MR & KM Hussey

5th August 2024

Pins Reference EN010137 Mona Offshore Wind farm
Interested Party Numbers MNOW-S57019 & MNOW-S57018

Copy of the graphical data taken from Appendix B20

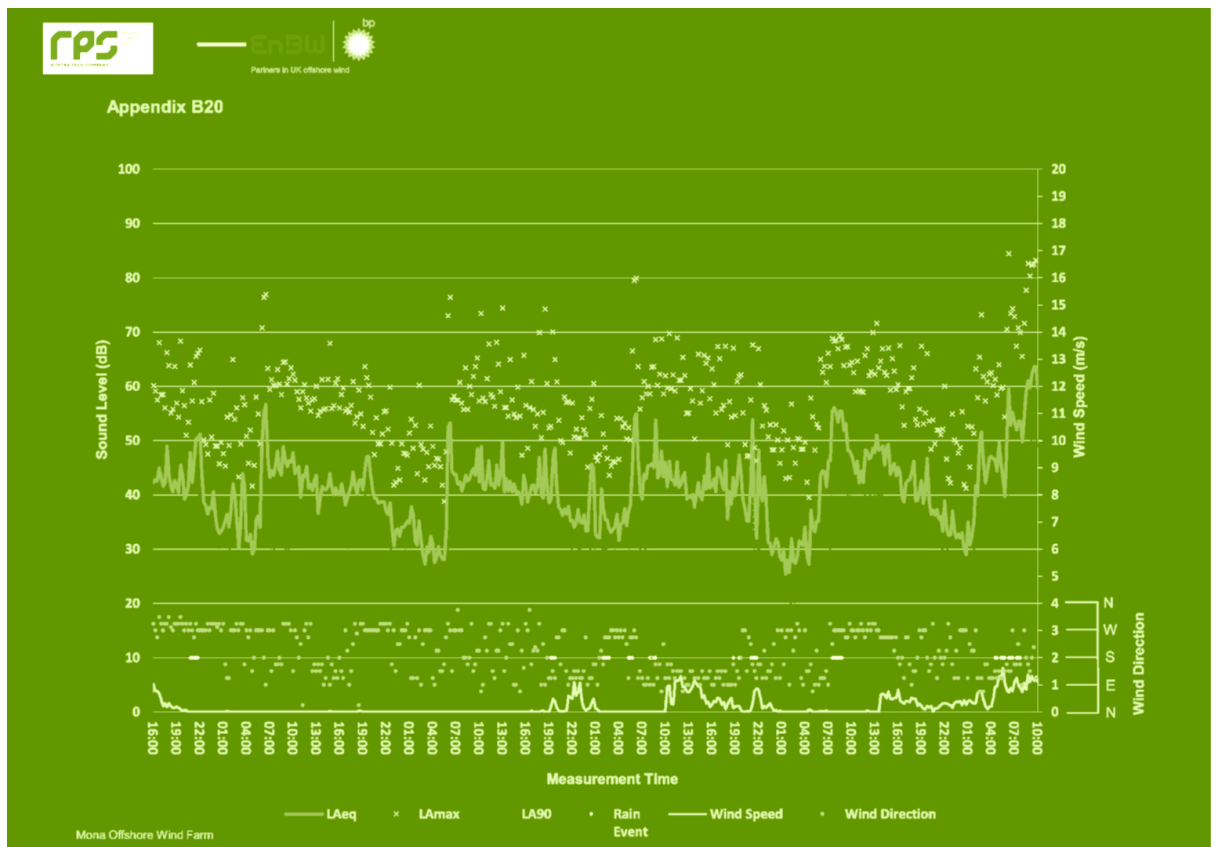
To which we make the following observations:

- There appear to be outliers (peaks) at the start of each day and a step change in increased dB levels on the final day.
- Some rain fall and maximum wind speeds of around 1.5m/s are recorded.

- a) The peaks at start of day where noise levels increase by around 15dB (occurring between 06.00 to 06.30) appear unique to this site as no similar results were recorded at Maes Cefn or Plas Hafod, being the closest survey stations at the time.

- b) The applicant states that any periods where precipitation events or wind speeds >5m/s then the data was omitted during analysis so an assumption is made that for the periods where rain was recorded that they have been omitted, however the wind speeds noted appear open to question:

- Weather results recorded were from equipment positioned at Maes Cefn which is on the opposite side of a hill, to the West, sitting between our properties and it is common to experience different wind conditions

- The wind speed results recorded do not reflect that which we observed at the time nor Meteorological Office data.
 - We noted it being very gusty on the 19th September all morning

- Although the Meteorological Office wind speed data is recorded in Knots (5m/s = 9.7Kn) it does support our observations and would reasonably explain the step change in increased recordings on the last day.
- It is also worth noting that on the penultimate day (18/9/23) where daily mean wind speed of 8Kn and maximum gust of 26Kn are recorded by the Meteorological Office that these wind speeds do not appear to be reflected in the weather data recorded by the applicant.

The step changes early each morning have now been explained by the applicant with the frequencies recorded and time being most likely attributed to bird noise, however high and gusty winds on the final morning would logically explain the increased noise levels recorded that day and that, if omitted, would reduce the base line dBA figure by several points.

Therefore on this basis we consider the baseline noise levels published for our property to have been over stated.
